COMPANY: CRESTAUDIO		TITLE: HP8 MONO PCB	
ORG DRAWN: TAZ	DATED: 1/20/04	CODE: D	SIZE: 76D5475
CHECKED:	DATED:	DRAWING NO: HPOPMMNO.SCH	REV: 00
CUR REV DRAWN:	DATED:	FILE NAME:	SCALE:
RELEASED:	DATED:	SHEET: 1 OF 2

ORG DRAWN: TAZ		DATED: 1/20/04		COMPANY: CRESTAUDIO	
CHECKED:		DATED:		TITLE: HP8 MONO PCB	
CUR REV DRAWN:		DATED:		CODE: D	SIZE: D
RELEASED:		DATED:		DRAWING NO: 76D5475	REV: 00
				FILE NAME: HPOPMMNO.SCH	
SCALE:				SHEET: 2 OF 2

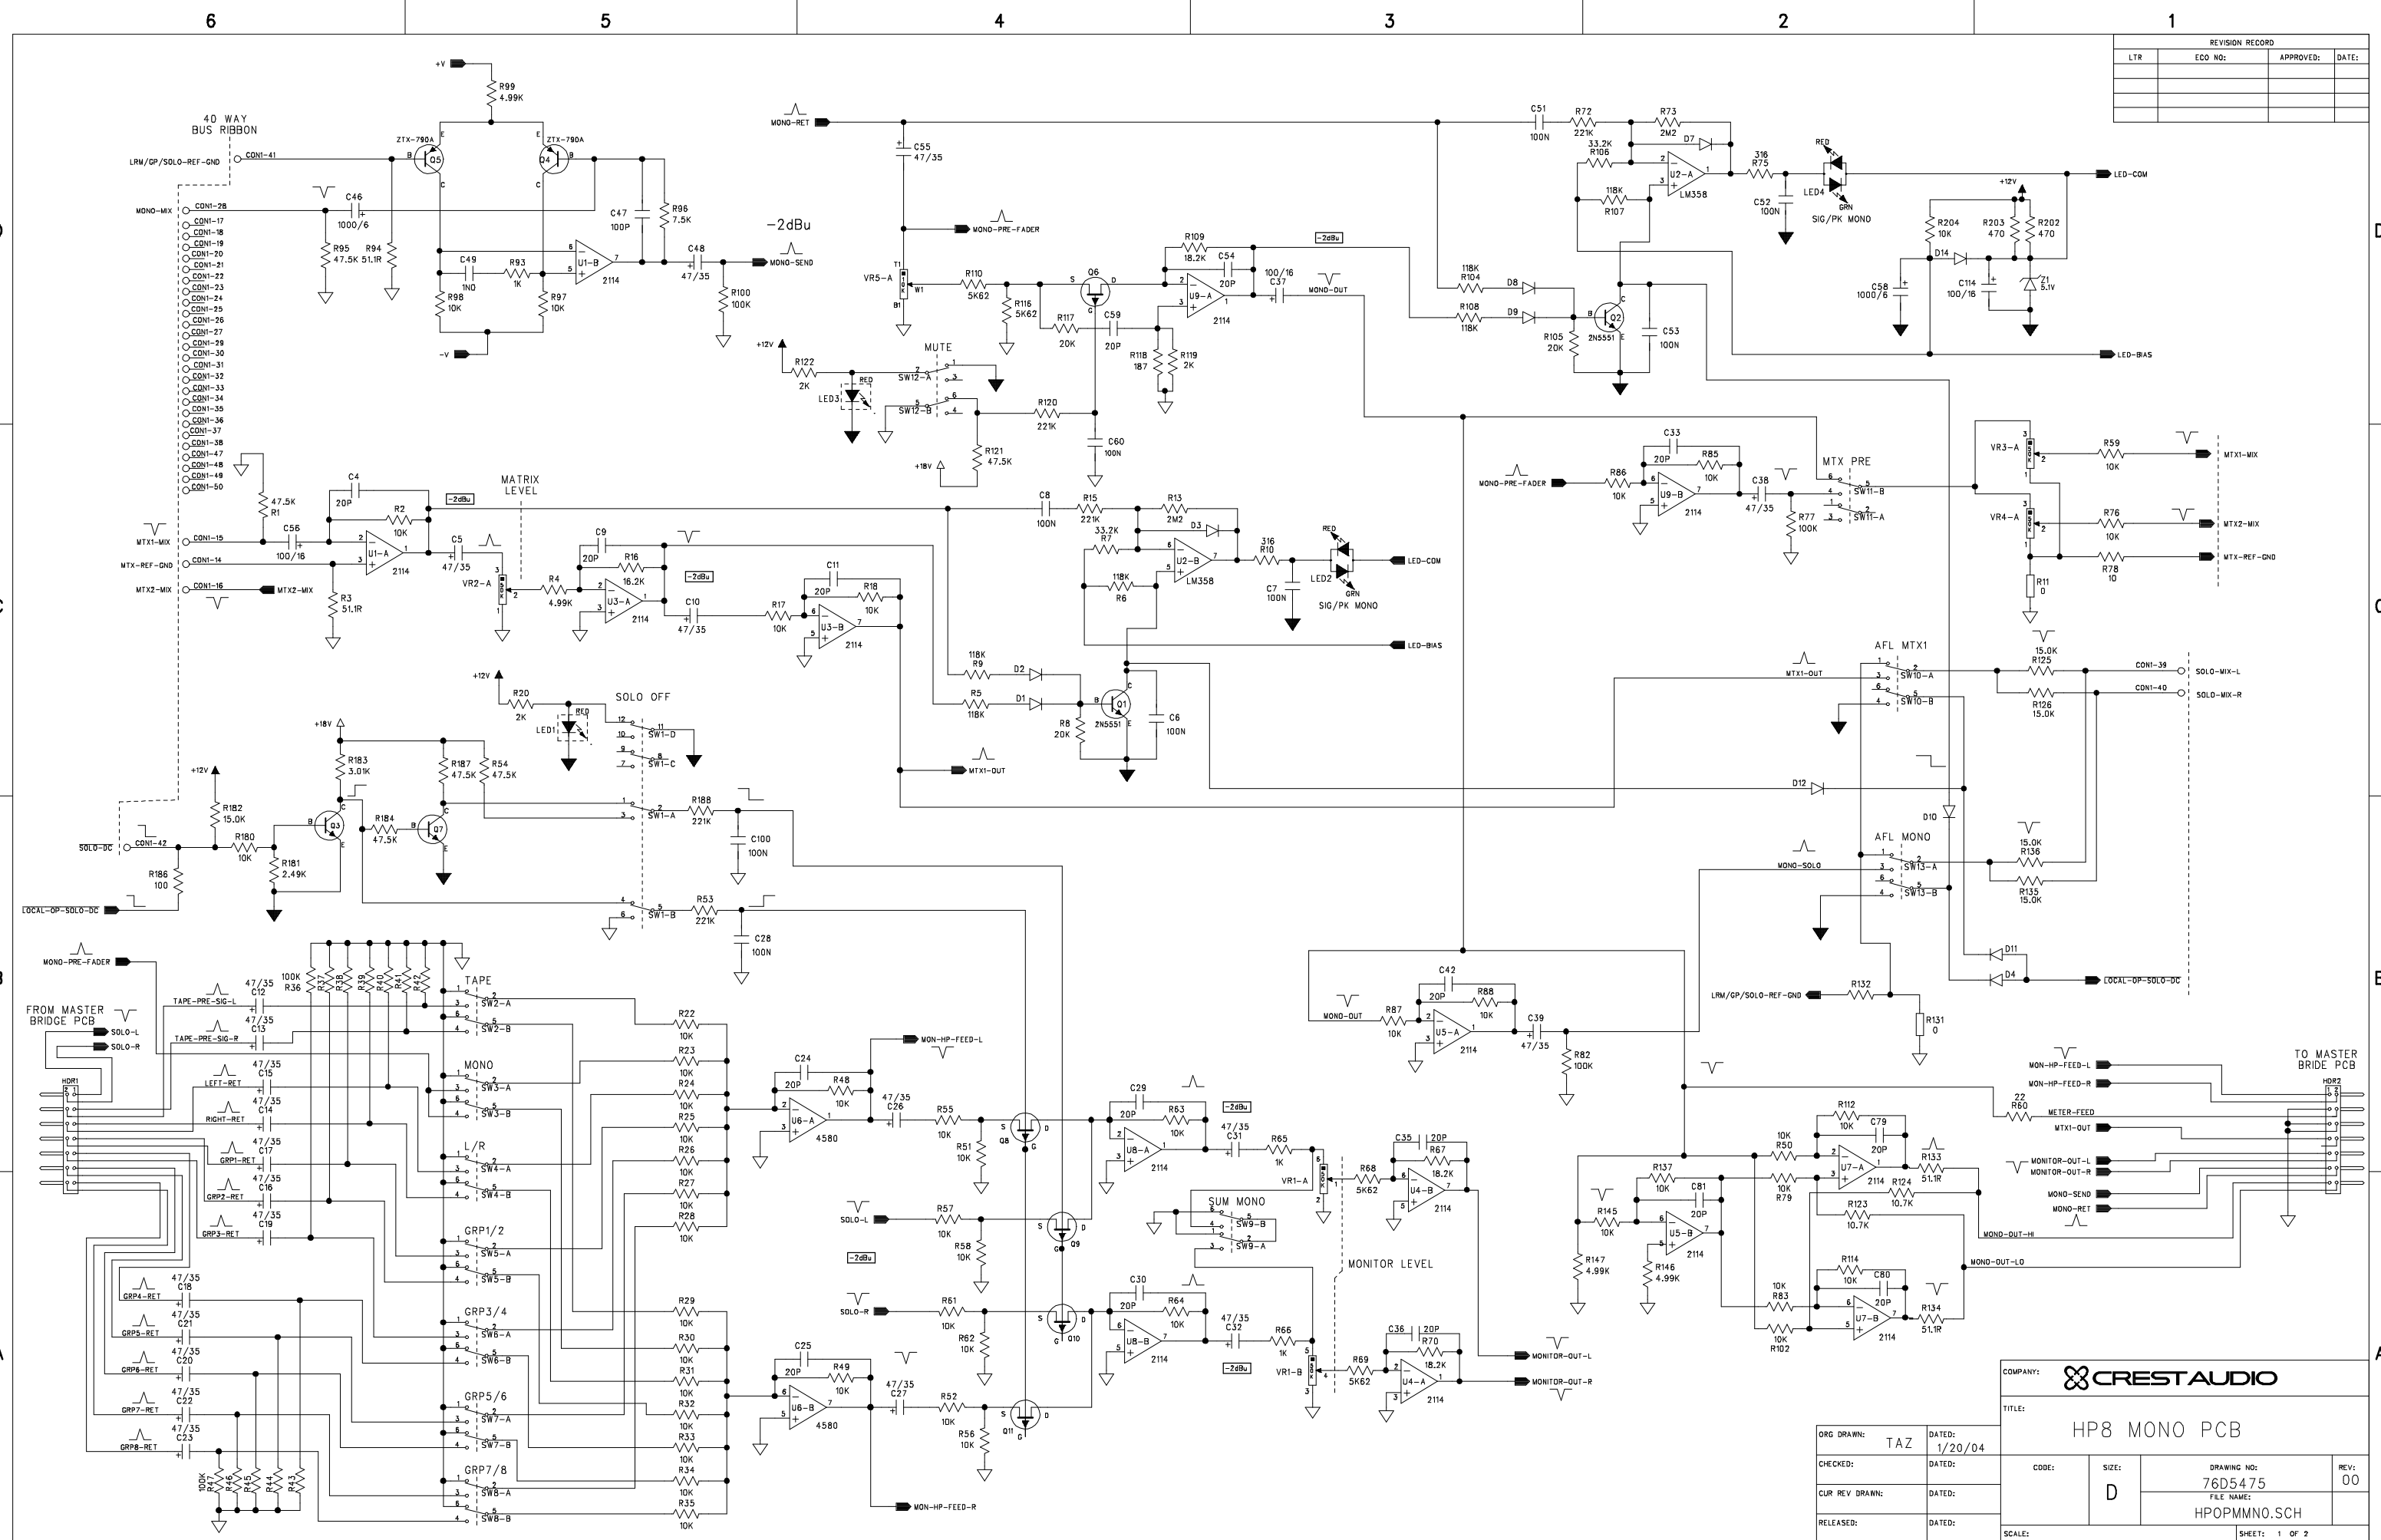
REVISION RECORD					
REV LEVEL	ASMBLY LEVEL	DATE	ECO	ENG.	DESCRIPTION
A	A	9/03		TAZ	PROTOTYPE PCB
B	A	10/29/03	DCO 1344	TAZ	PCB REVISION FROM A TO B MOVED ALL SWITCHES UP BY 0.060" TO USE NEW SWITCH CAPS SO AS SAME HEIGHT AS SWITCHES ON INPUT MODULES - INTERNAL WORKING LEVEL CHANGE FROM +4dBu TO -2dBu CHANGE R109 FROM 33K2 TO 18K25 CHANGE R8, R105 FROM 10K7 TO 20K CHANGE R125, R126, R136, R135 FROM 30.1K TO 15K CHANGE R112, R114 FROM 4K99 TO 10K CHANGE R123, R124 FROM 5K62 TO 10.7K CHANGE R4 FROM 7K5 TO 4K99 CHANGE R16 FROM 30.1K TO 16K2 - MUTE TRIM CHANGE R118 FROM 499R TO 187R - REMOVE GLITCH THAT OCCURRS WHEN SOLO SWITCH RELEASED ADD C3 AND C34 (100nF) - REDUCE CURRENT SINK DEFICIENCY OF Q3 (SOLO TRANSISTOR) CHANGE R183 FROM 1K TO 3K - MONO MUTE SWITCH TRACKED WRONG (REVERSED FUNCTION)
00	A	1/20/04		TAZ	PCB REVISION FROM B TO 00 - PRODUCTION RELEASE. REMOVE C3 AND C34 (100nF) -CAUSING GLOBAL SOLO GLITCHES.
